## Product Change Notification / SYST-25LGPN222

ERRATA - PIC16(L)F15324/44 Family Silicon Errata and Data Sheet Clarification Errata Document Revision

## PIC16(L)F15325/45 Family Silicon Errata and Data Sheet Clarification

#### 2.1 Figure 37-5: Clock Timing

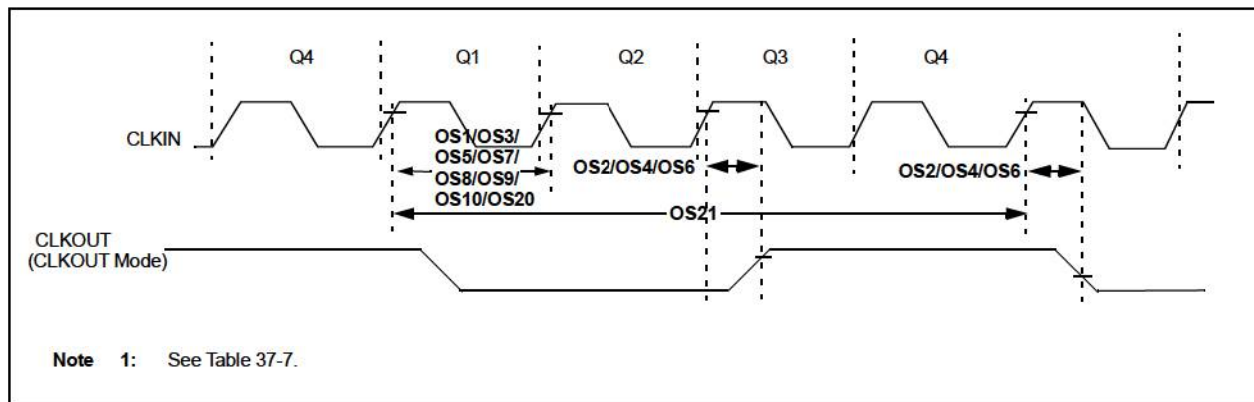
Figure 37-5 incorrectly shows the location of parameters OS1, OS2, OS3, OS4, OS5, OS6, OS7, OS8, OS9, OS10, OS20 and OS21. The correct location for the above-mentioned parameters is depicted in the following figure.

#### 2.2 Figure 37-9: Brown-Out Reset Timing and Characteristics

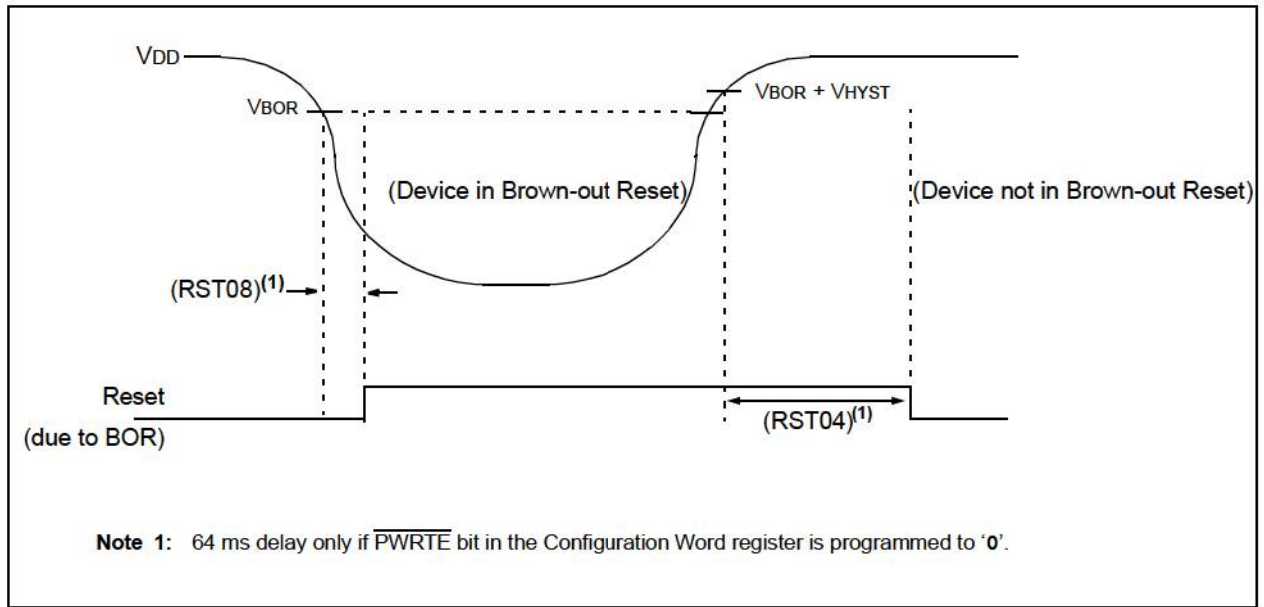
Note 1 in Figure 37-9 is incorrect. The correct note along with the figure is depicted below.
